# SERVICE LETTER

No. 392

Piper Aircraft Corporation

**SUBJECT:** Inspection and Adjustment of Nose Wheel Shimmy Dampener Assembly

SERVICE LETTER 392

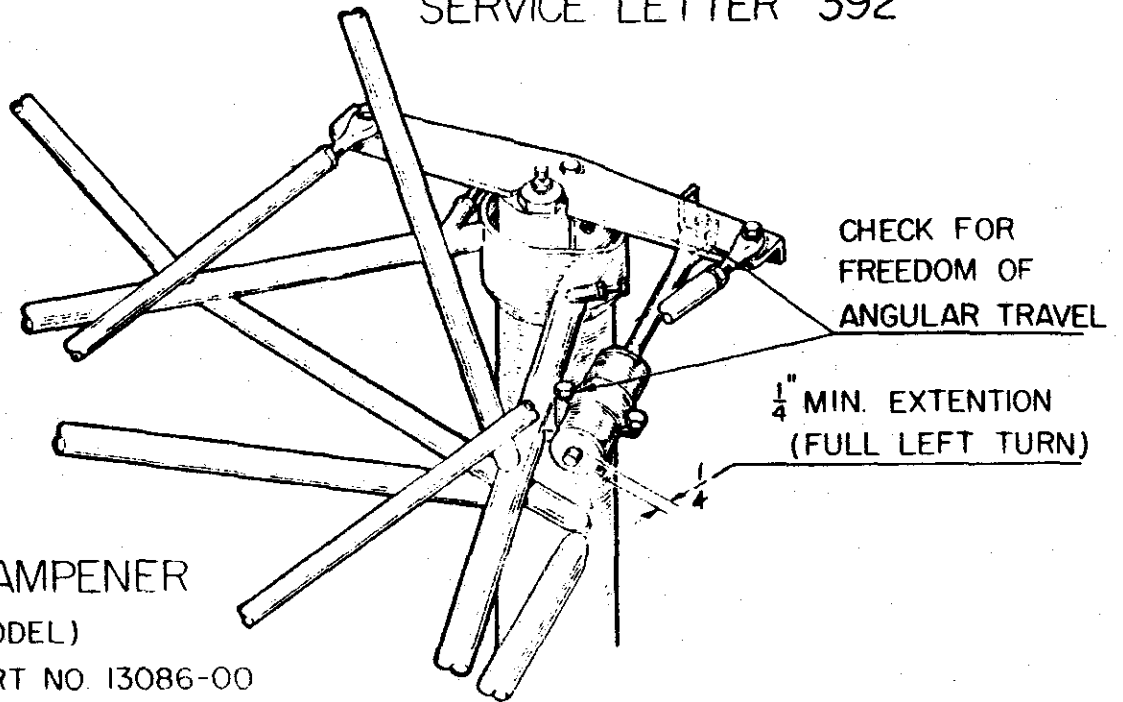
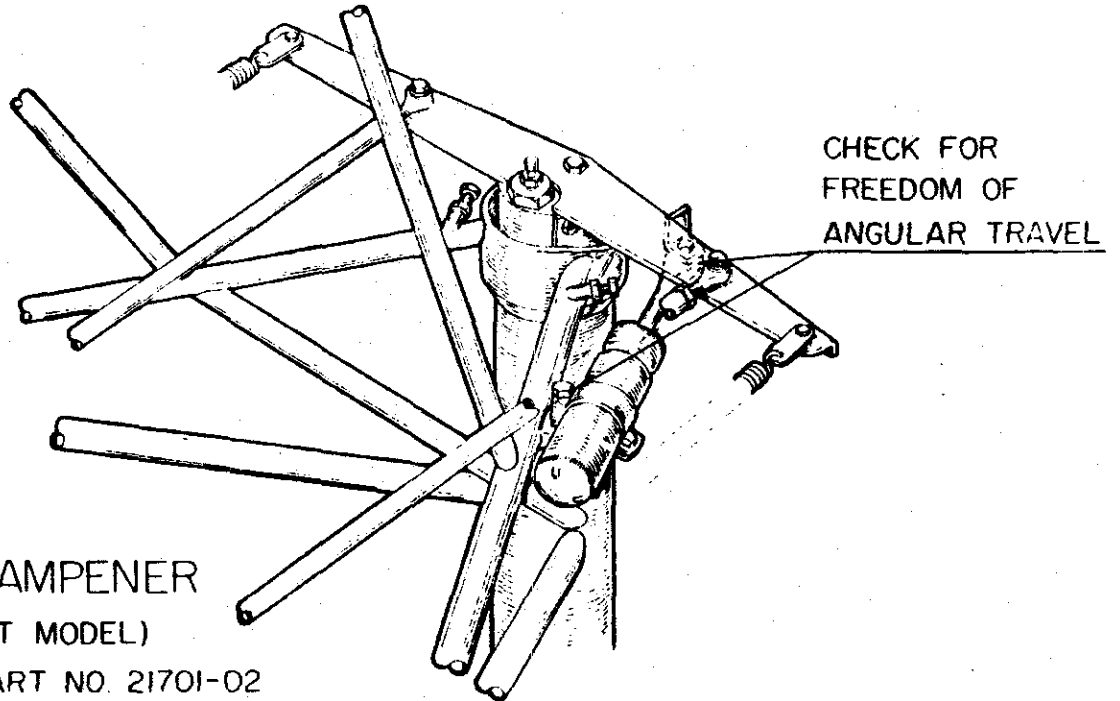
- I. Should the above systems become maladjusted on aircraft equipped with the early model nose wheel shimmy dampener, part number 13086-00, it is possible that, in a maximum left turn, the shaft of the shimmy dampener may enter the end of the dampener housing and jam; thus making any further movement of the nose wheel impossible.

- II. It may also be possible that, through lack of attention during maintenance and inspection, the shimmy dampener may "freeze" to its attachment to the nose wheel structure. In other words, at large angles of nose wheel steering, relative angular travel must be maintained for the dampener. Should the bolt which attaches the dampener become corroded to the supporting structure etc., it would be possible to bend the shaft at the point where it exits from the dampener body.

- III. Freedom of angular travel must also be maintained at the point where the rod end attaches to the nose wheel steering arm. Lack of angular travel at this point could cause bending of the dampener shaft or bending of the rod end with possible failure of the rod end in the threads.

In view of the above, the following inspection will be required. On the Monroe type shimmy dampeners, part numbers 21701-02 and 21701-04, prior to but not later than the next 100 hours of operation and becoming part of the normal maintenance and routine inspection thereafter. On aircraft equipped with the earlier type shimmy dampener, part number 13086-00, prior to but not later than the next 25 hours of operation and becoming a part of the normal maintenance and routine inspection thereafter: (Refer to attached sketch)

1. Determine that the nose wheel travel is 20° left and right.
2. Determine that the shimmy dampener rotates freely on the axis of its attachment bolt when approaching the limits of nose wheel travel.
3. Determine that the attachment of the rod end to the nose wheel steering arm is free to accept angular travel.
4. The shimmy dampener should be adjusted, if necessary, so that at full left nose wheel travel, not less than 1/4 inch of the shaft shall be exposed on the back side of the dampener. (Applicable to early type shimmy dampener, part number 13086-00 only.)
